**GUARDIAN**
REAL ESTATE SERVICES LLC

DESIGN ADVICE
REQUEST 002
JUNE 2015

BLOCK 290

DAR 01 comments | challenges

park edge | open space

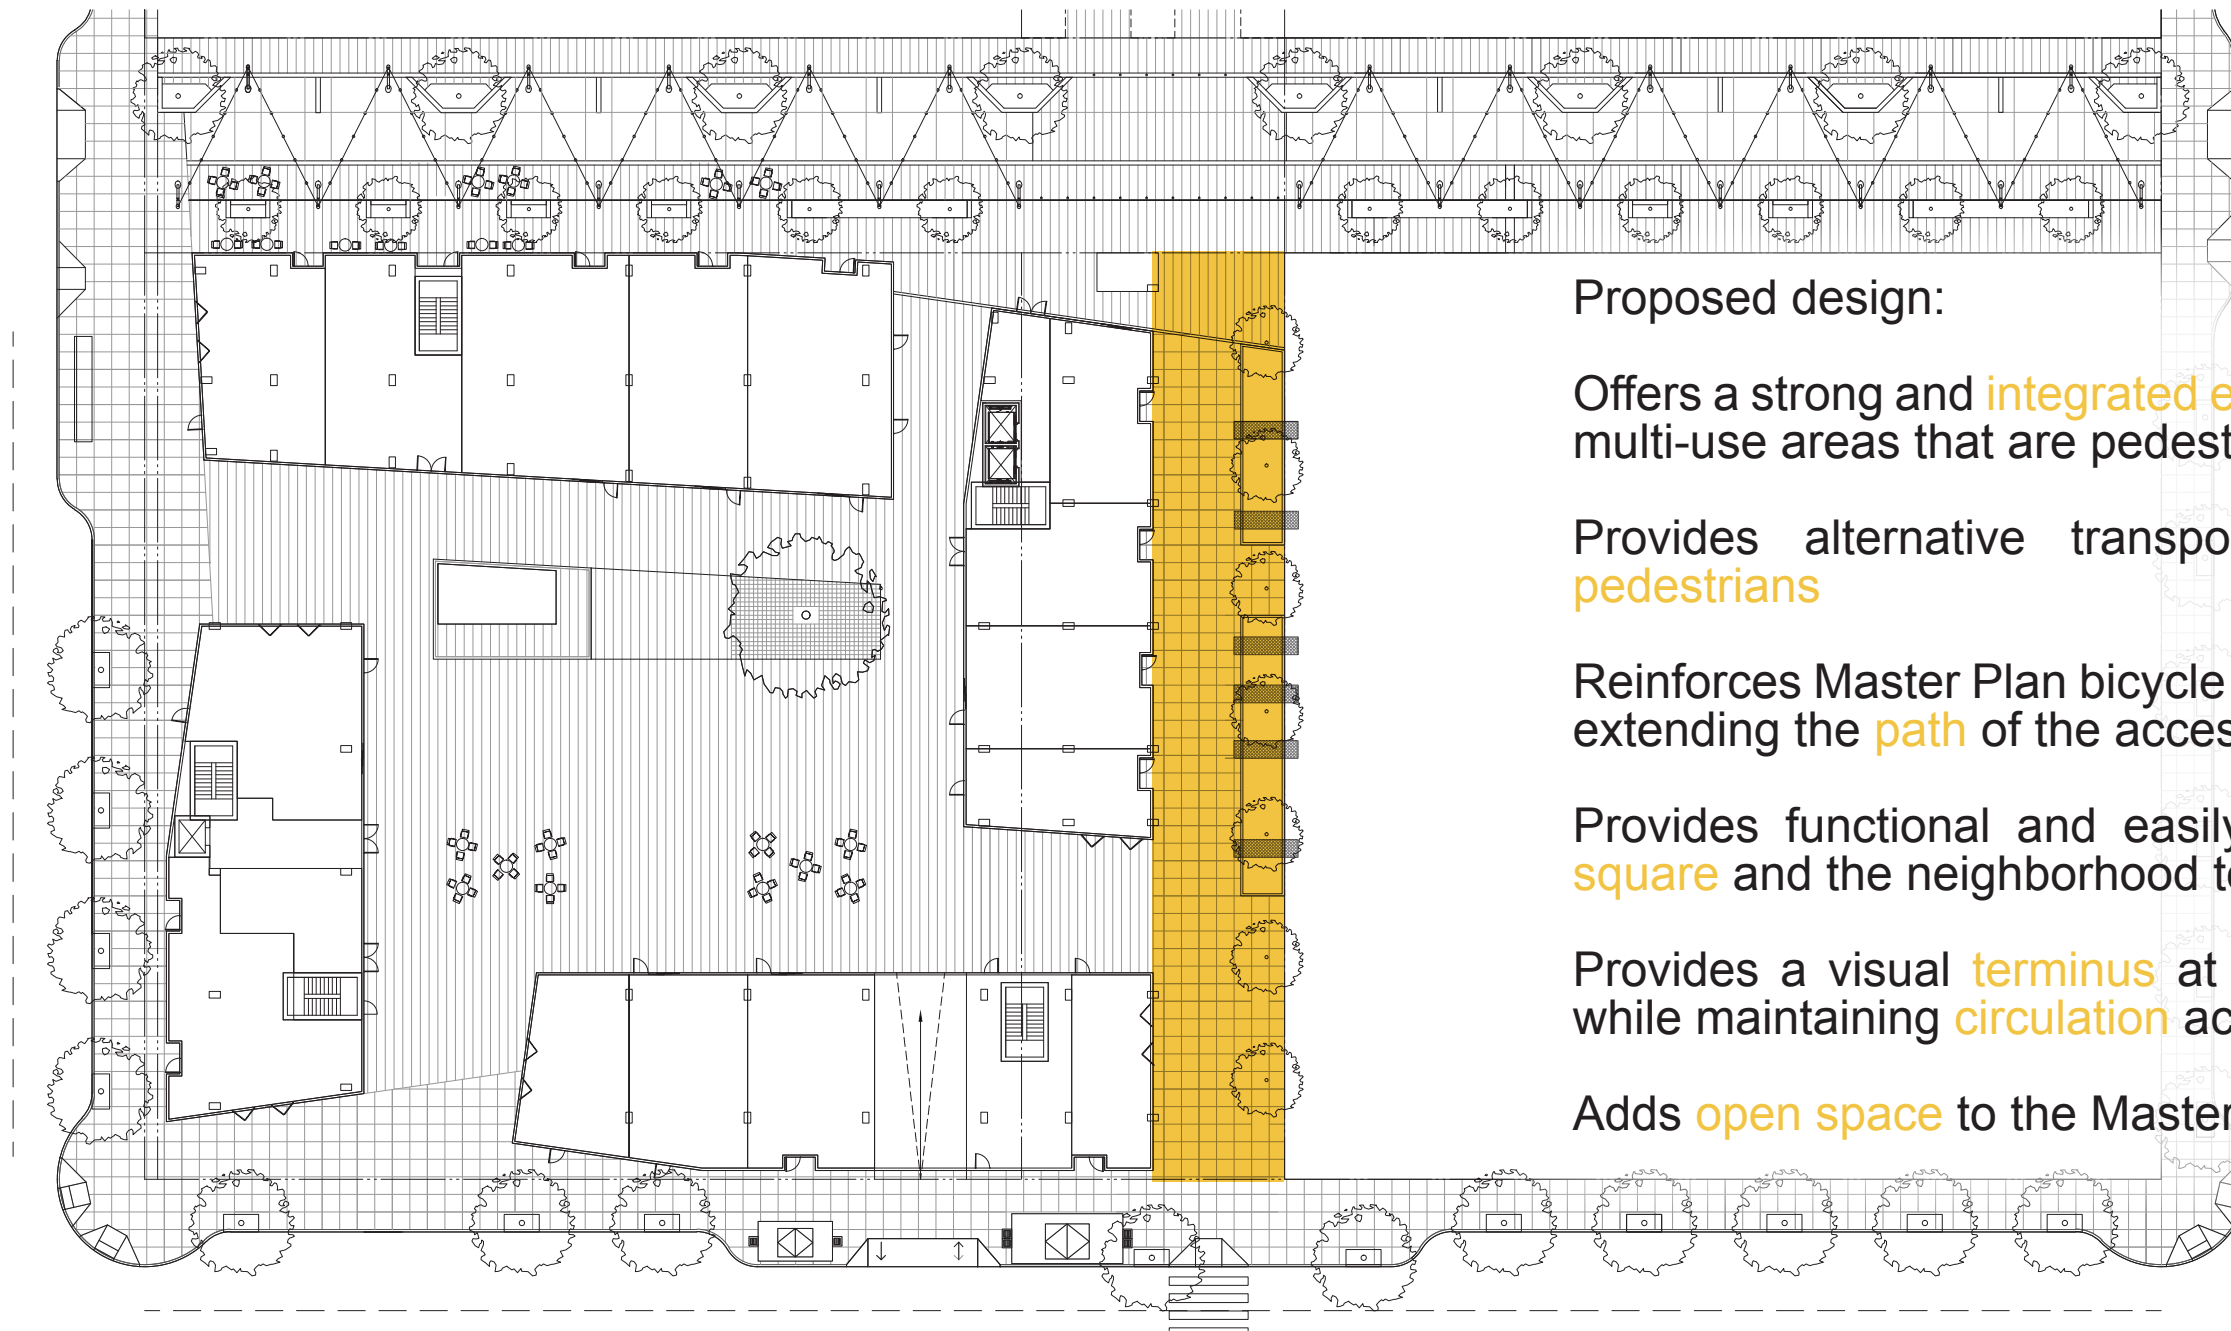
1. Move eastern buildings to the west, creating a meaningful interface with the park and clear path along the park edge while maintaining the spirit and activity of the Square.

Proposed design:

Offers a strong and **integrated edge** along the neighborhood park with multi-use areas that are pedestrian friendly

Provides alternative transportation systems for **bicycles** and **pedestrians**

Reinforces Master Plan bicycle and pedestrian **circulation** patterns by extending the **path** of the accessway to NW Pettygrove

Provides functional and easily-navigable **access** to the **park**, the **square** and the neighborhood to the south

Provides a visual **terminus** at the Southern end of the accessway while maintaining **circulation** across the site

Adds **open space** to the Master Plan at the Square **forecourts**

square design

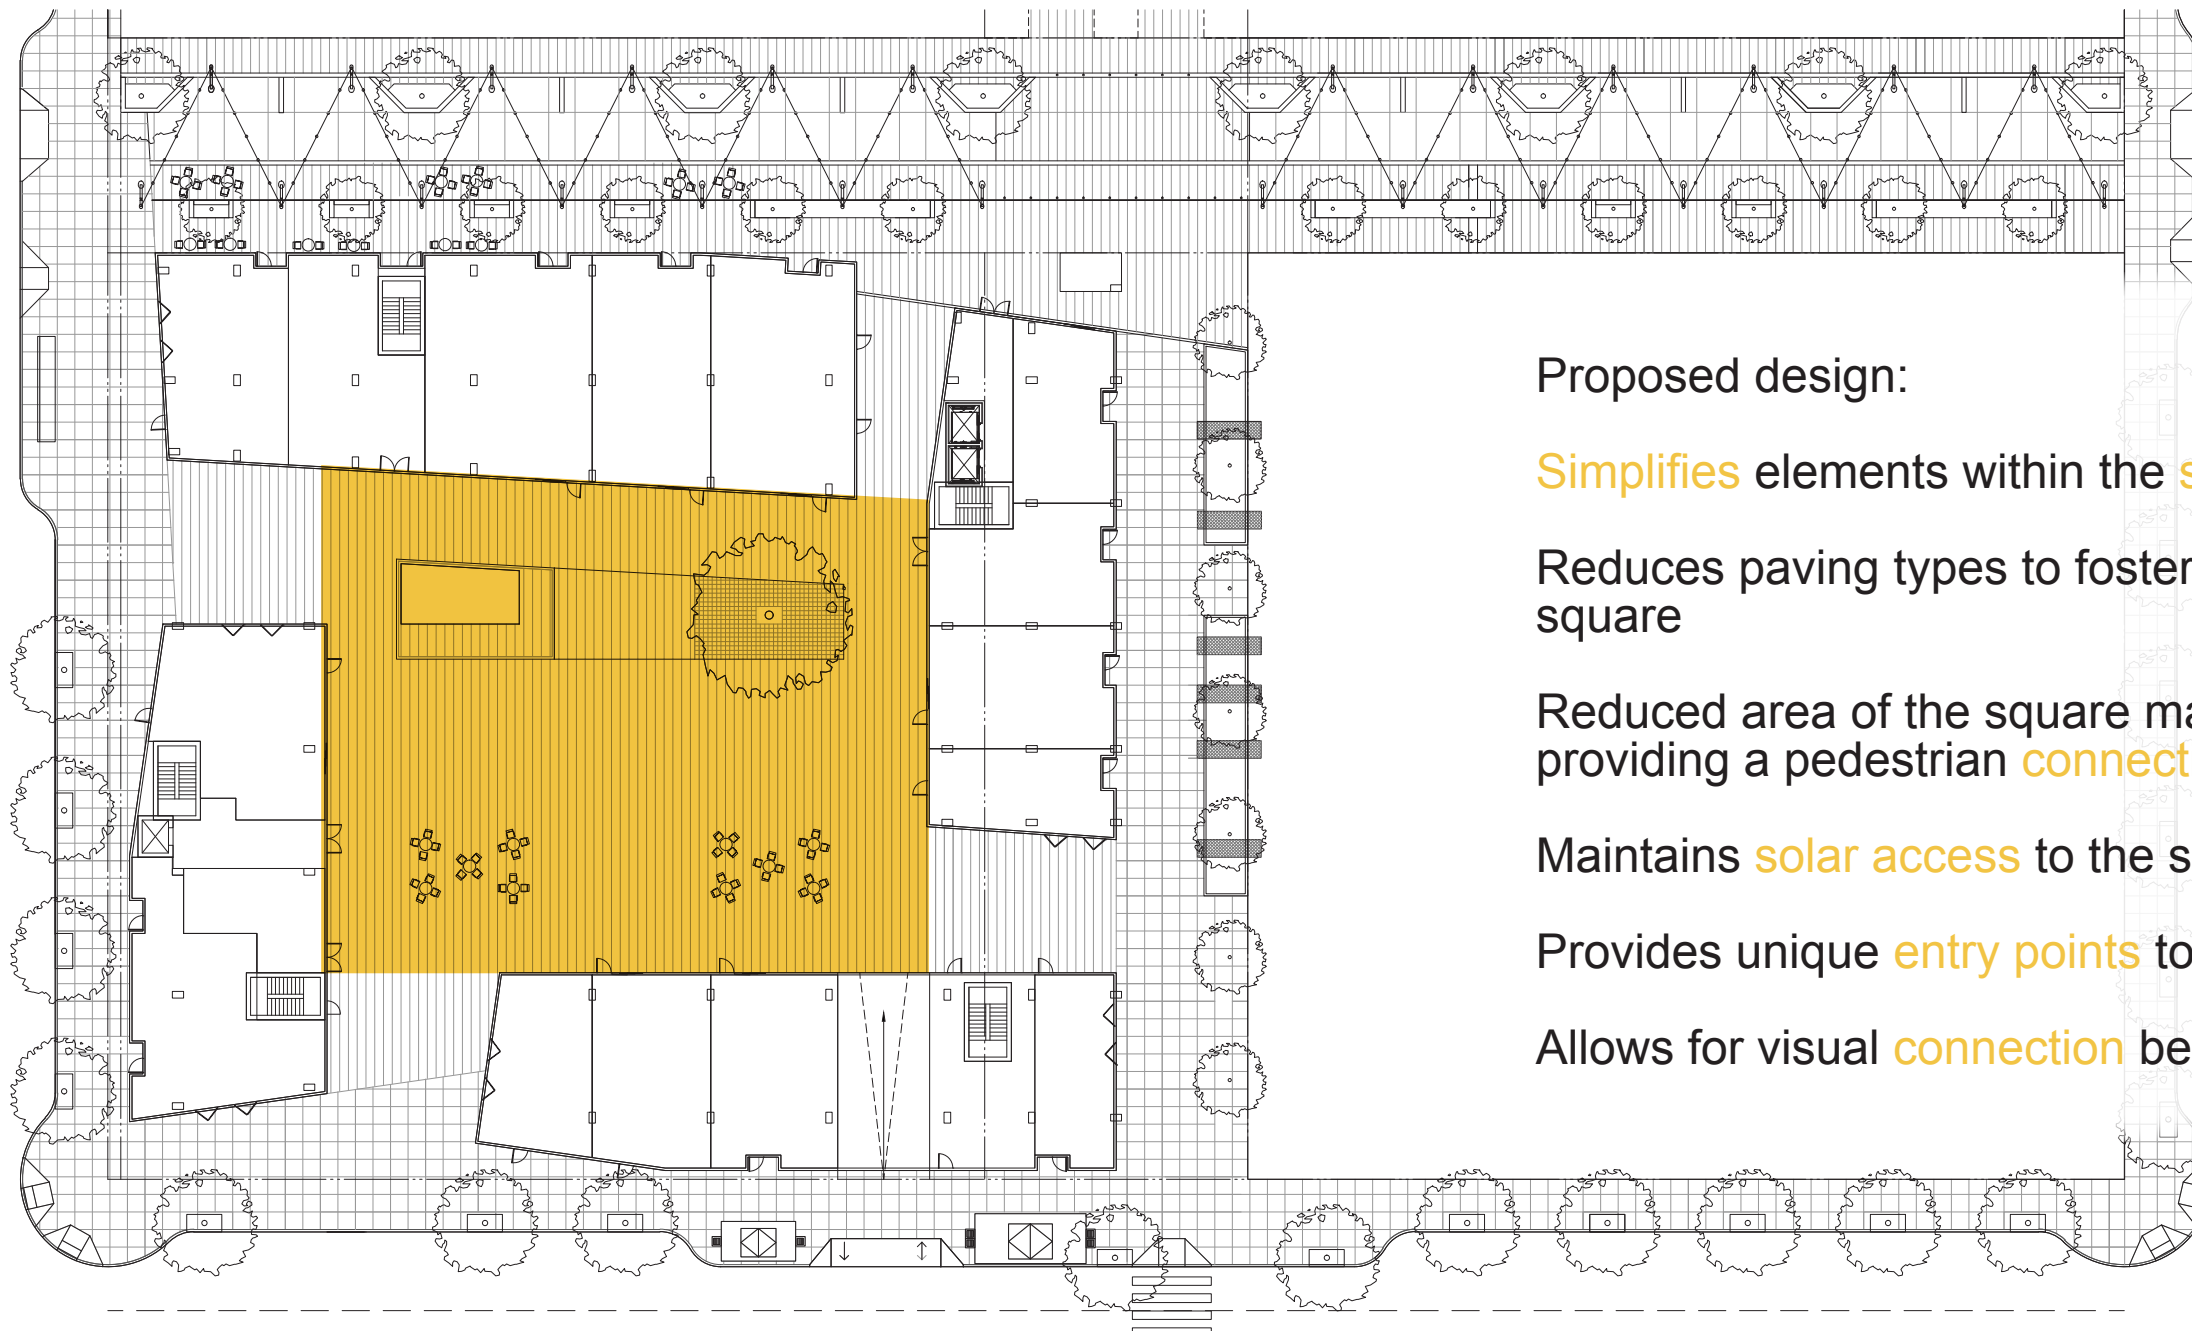
2. Simplify the Square materials and landscape design to provide a versatile public space that is active throughout the day.

Proposed design:

Simplifies elements within the square

Reduces paving types to foster more freedom of use within the square

Reduced area of the square maintains four-sided enclosure while providing a pedestrian connection along the park edge

Maintains solar access to the square

Provides unique entry points to the square on all four sides

Allows for visual connection between 21st Avenue and the park

building heights

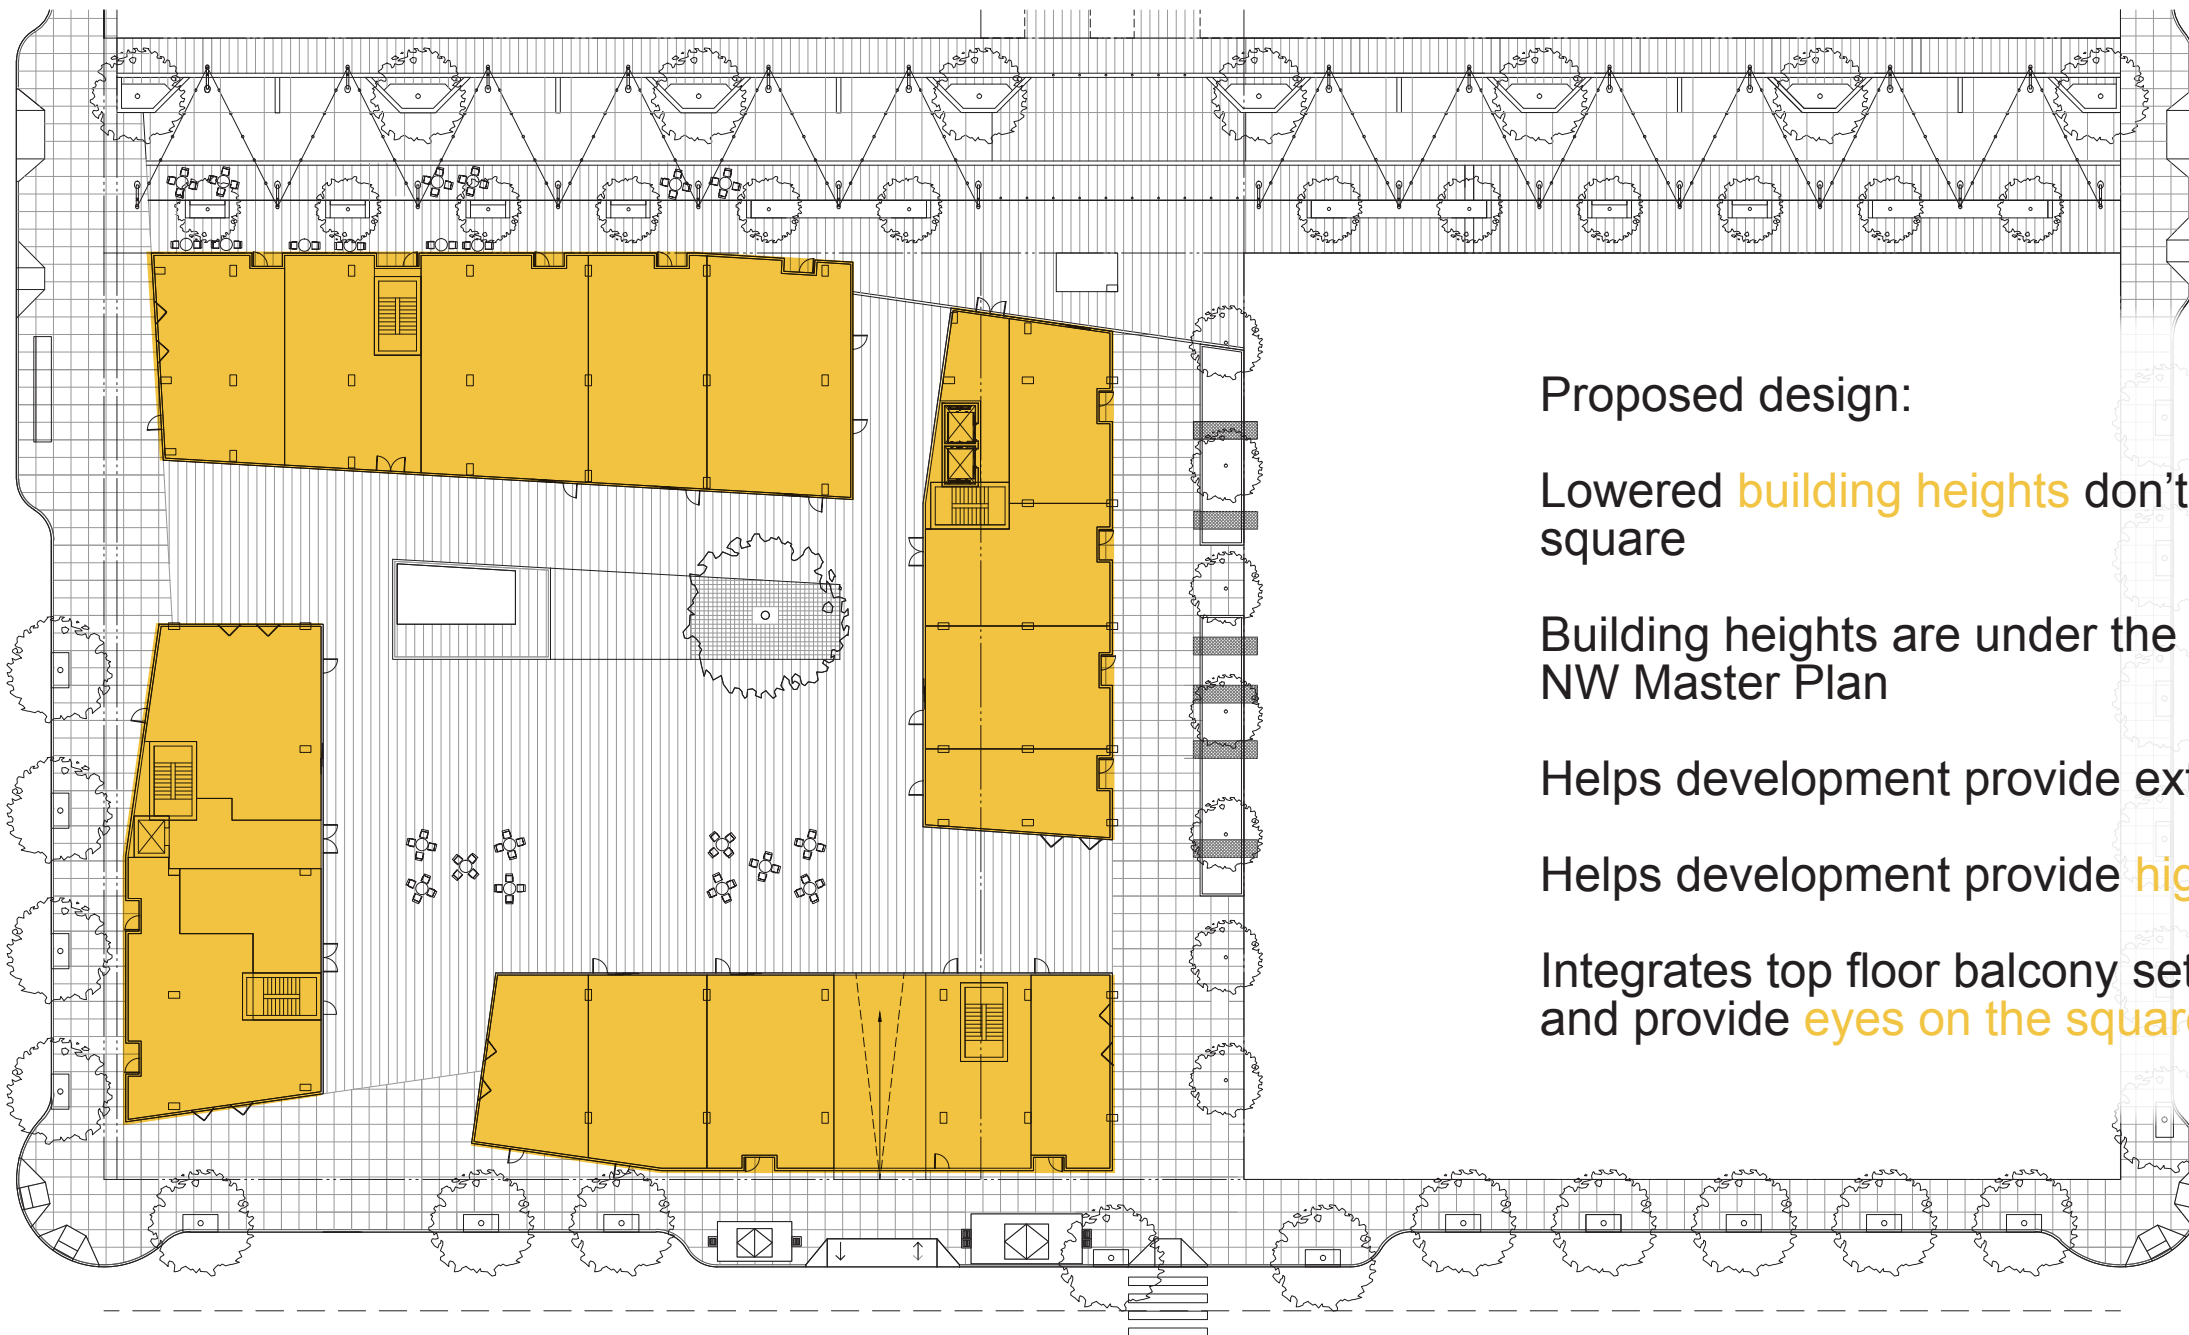
3. Provide adequate building height to support the project while ensuring solar access, both of which are critical to the vibrancy and success of the Square.

Proposed design:

Lowered **building heights** don't significantly alter **solar access** to the square

Building heights are under the maximum **allowable heights** per the NW Master Plan

Helps development provide extensive **public amenities**

Helps development provide **high-quality materials**

Integrates top floor balcony setbacks to **reduce the building scale** and provide **eyes on the square**
